SUBJECT: Conference Call with Entergy Operations, Inc.

On August 4, 2000, Jay Lee and D. H. Jaffe held a conference call with the River Bend Station (RBS) licensee to discuss the effect of the proposed 5% power uprate on offsite and control room, post accident, radiation doses. Enclosure 1 was the agenda for the conference call. The licensee provide Enclosure 2 to assist in the conference call. Enclosure 3 was prepared following the conference call and was received on August 8, 2000.

River Bend Discussion Items

- (1) License Amendment Request (99-15), "Changes to Technical specifications for Power Uprate of River Bend station".

LOCA DOSE MODEL - POWER UPDATE

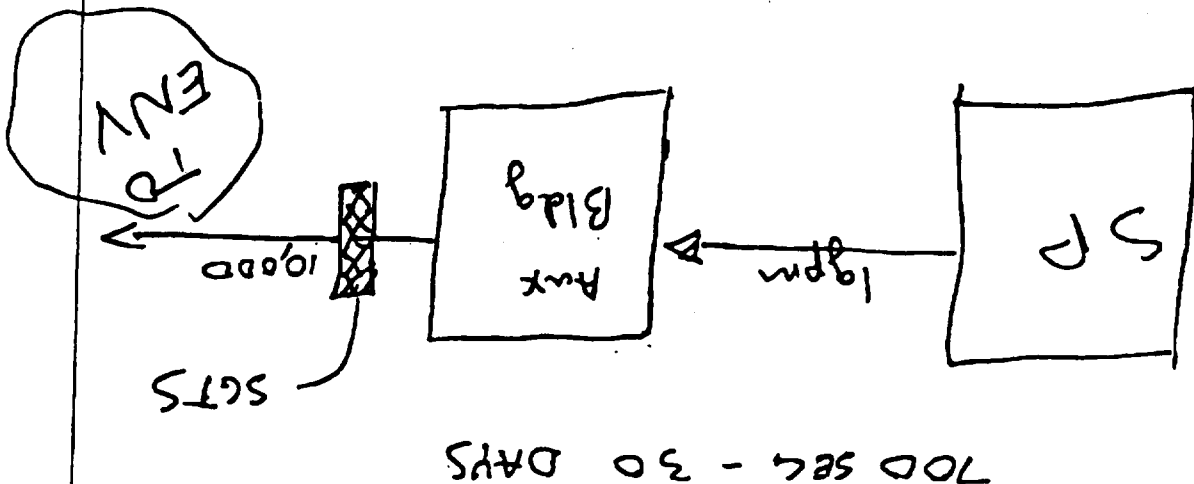
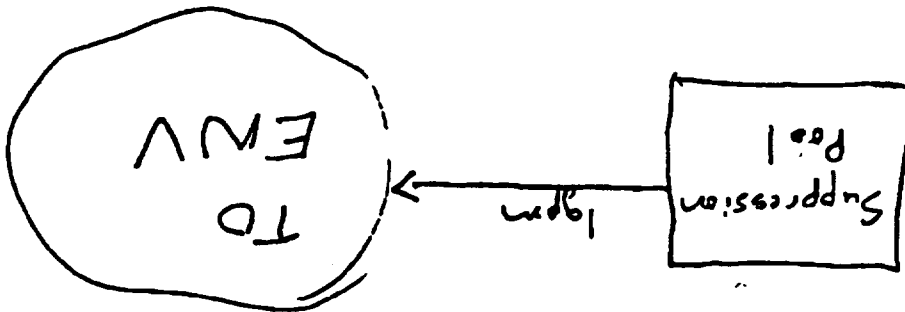
Are your LOCA dose consequences provided in LAR 2000-02 based on with or without MS-PLCS leakage contribution?

How does LAR 2000-02 relate to LAR 99-15? What are the current River Bend licensing bases for the radiological consequences ?

The purpose of this addenda is to determine the LOCA doses including the impact of Power Uprate. The two major changes due to Uprate are (1) an increased core thermal power (3100 MWt in lieu of 3039 MWt) and (2) an extended positive pressure period (24 to 724 seconds for annulus, 0 - 724 for the auxiliary and fuel buildings).
